# SERVICE MANUAL

## COLOUR TELEVISION

### AV-32WL1EU AV-32WL1EI AV-32WL1EK

Supplementary

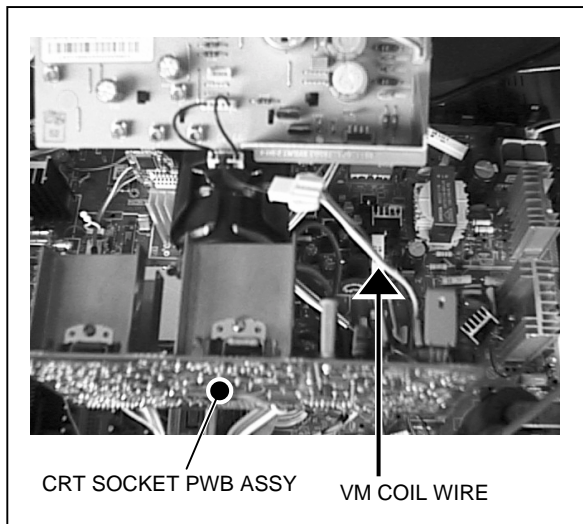
To improve CRT performance, CRT manufacturer has changed location of VM coil wire connector on the CRT neck.

When changing CRT from old to new type, it is necessary to add extension cable CHHB03-100R-SA, between CRT SKT PCB and new VM coil connector.

When ordering replacement CRT, Please order CHHB03-100R-SA at same time.

[Fig.1]

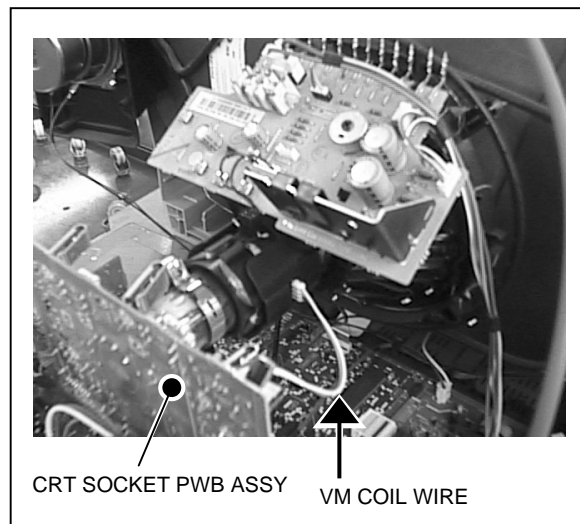
Old type: Has a short VM wire, coming from the CRT VM PCB/Coil Assy for connecting to CRT PCB VM coil wire.

[Fig.2]

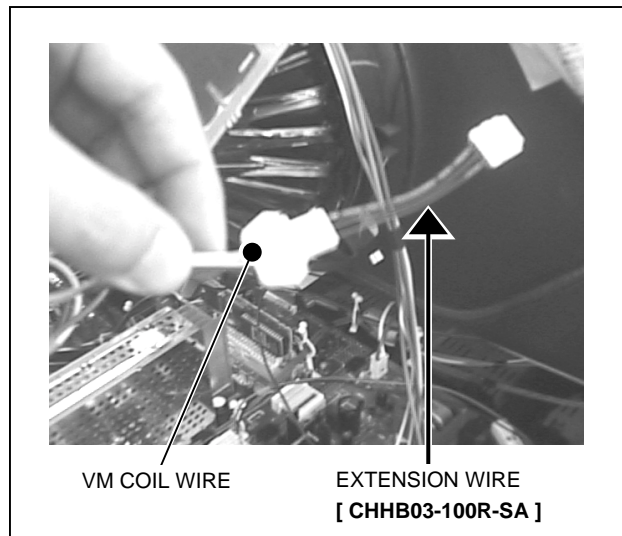
New type: VM coil wire is connected directly into the right hand side of CRT neck.

- ① Order CHHB03-100R-SA, at the same time as CRT.
- ② Attach one end of CHHB03-100R-SA, to VM coil Wire. (See Fig 3)
- ③ Insert opposite end of CHHB03-100R-SA wire, into CRT's VM coil wire connection. (See Fig 2)
